## Town of Kittery Planning Board Meeting May 13, 2021

### **459 U.S. Route 1—Major Modification Review to a Master Site Development Plan and Subdivision / Site Plan**

**Re: 459 US Route 1 - Kittery  
Major Modification**

SCALE: 1" = 100'  
DATE: 02/08/2018  
JOB NO: C091-21  
FILE: THE HOMESTEAD BASE  
DRAWN BY: BRN  
REVISION : DATE  
Q:04/14/2021  
SHEET 1.2

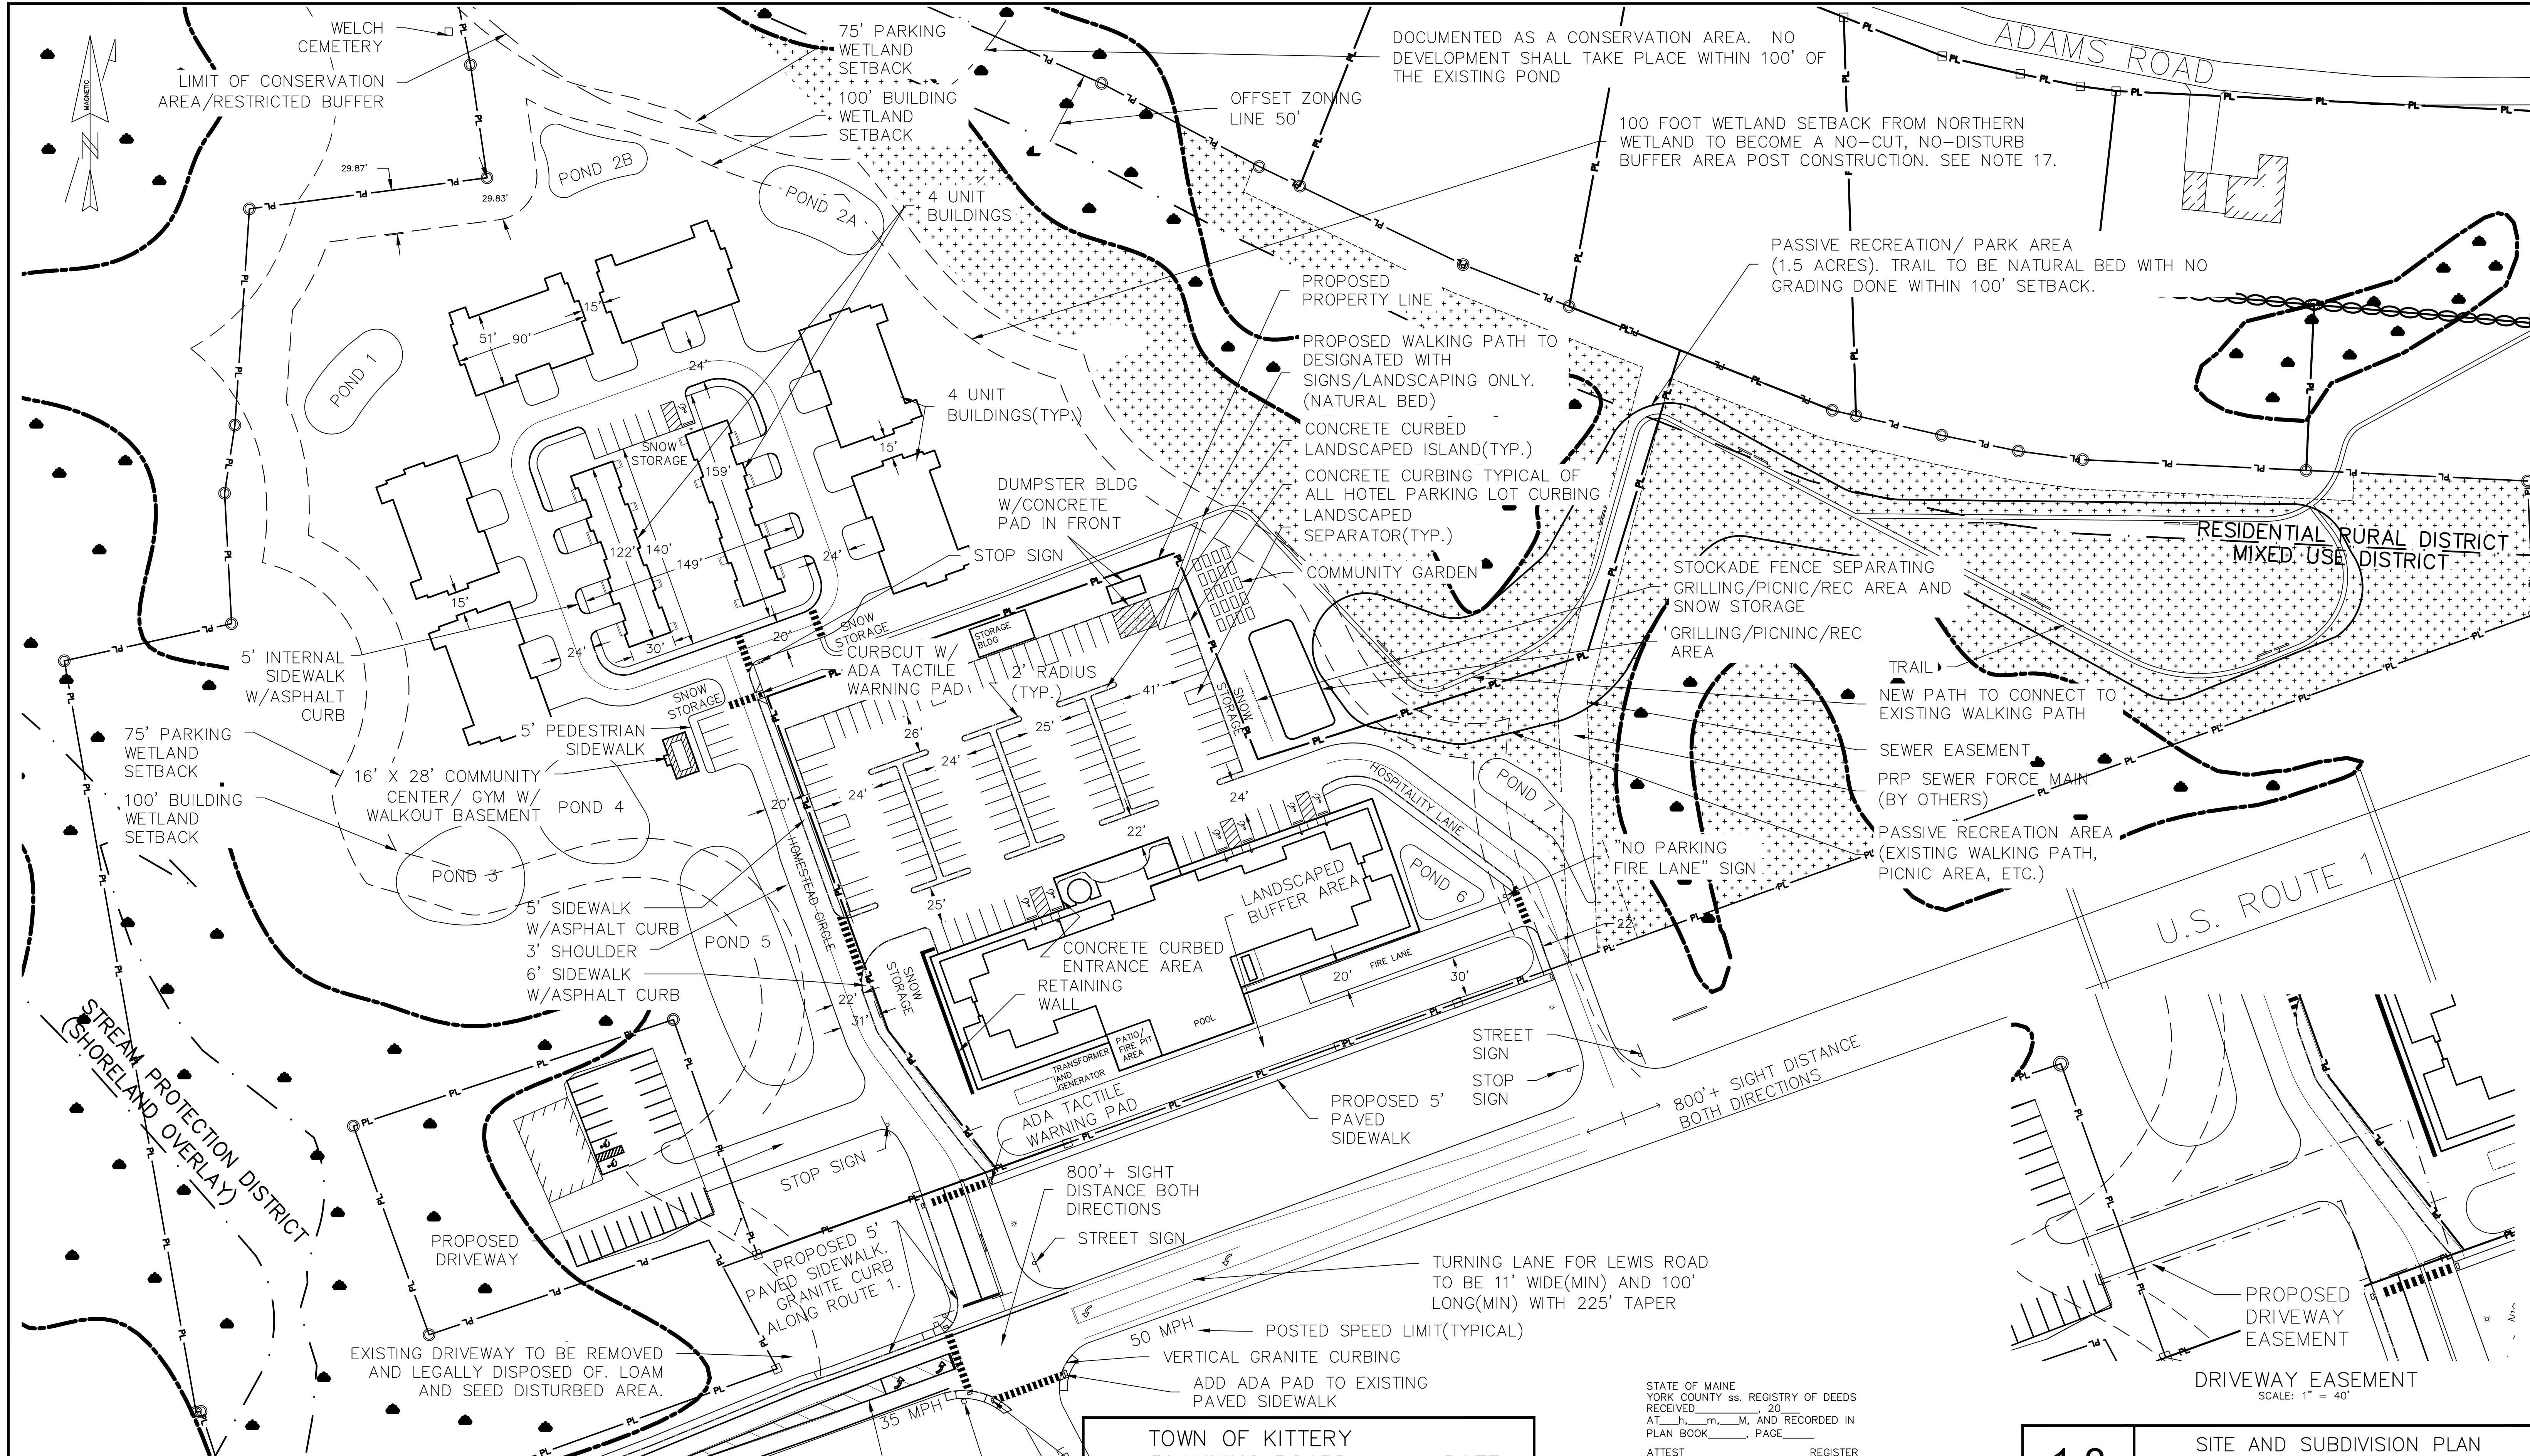
*D.2. In note 4 on Sheet 1.2, the applicant should list the provided setbacks, frontage, and lot size in addition to the required zoning information. (We note that this comment was included in our previous review from November 2018 and addressed in February 2020 but was not addressed in this submission).* **Note 4 has been updated to shown setbacks, frontage and lots size**

ACCESSIBLE PARKING SPACE DETAIL

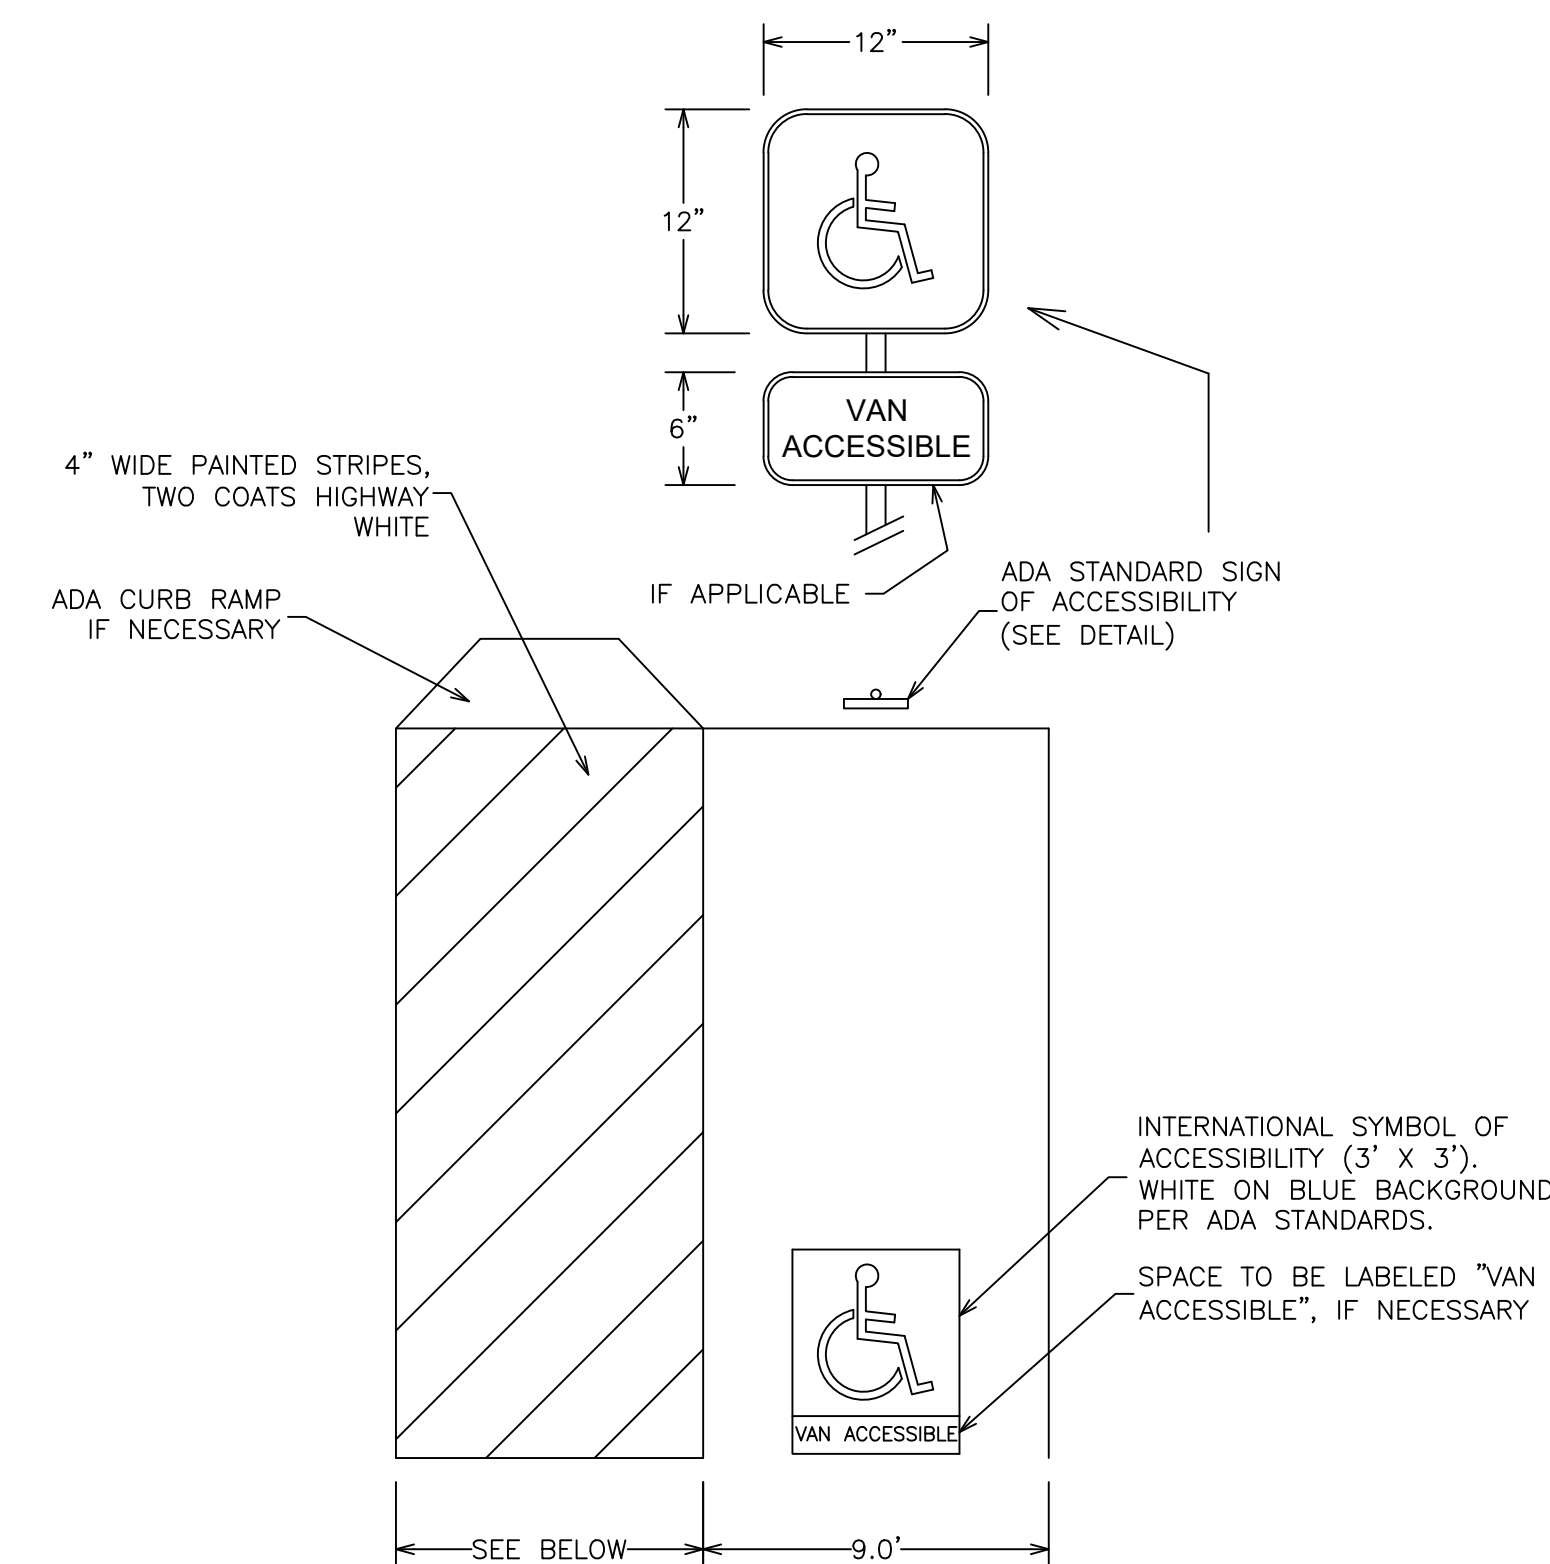
**16.8.9.4.D.1.1** *The applicant should show dimensions of the accessible parking spaces on the plans. (We note that this comment was included in our previous review from November 2018 and was not addressed).* **Plans updated to show typical parking dimensions for ADA Spaces.**
